Separation Distances and Amenity Supplementary Planning Document (SPD)

Consultation Statement

September 2024

↑ Illustration of the 45 Degree Check ✓

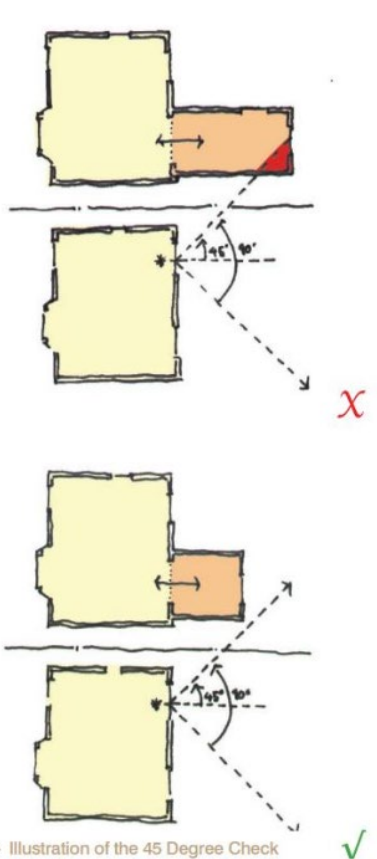
Ref. 4.18 The diagrams do not clearly illustrate the text as its difficult to ascertain the solid from the transparent.	Change proposed. Improvements will be made to the illustrations for the adoption version.
		Ref. 4.20 The last point refers to "opaque windows" (OPAQUE English meaning - Cambridge Dictionary) which would suggest they do not allow transmission of any light. Surely this should read "obscured windows".	Change proposed. Text amended: <ul style="list-style-type: none"> Use opaque obscure glazing...
		Ref. 4.22 The diagrams would benefit from a clarity caption "Where the 45 degree test cannot be met, the 25 degree test will be applied"	Change proposed. Title added to the diagrams of the 25 degree rule.
		Generally – one would assume none of this to apply at a distance beyond 21m.	No change required. The standard clearly states 21metres is a minimum distance.
3	Glen Baker-Adams Development Management	Just one observation from me in that this diagram seems to use odd conventions for staying what is acceptable and not.	Noted. No change is considered necessary however changes to improve the consistency of ticks and crosses adjacent to the illustrations will be reviewed for the adoption version.

I would prefer you used a consistent approach like in previous diagrams

X or **✓**
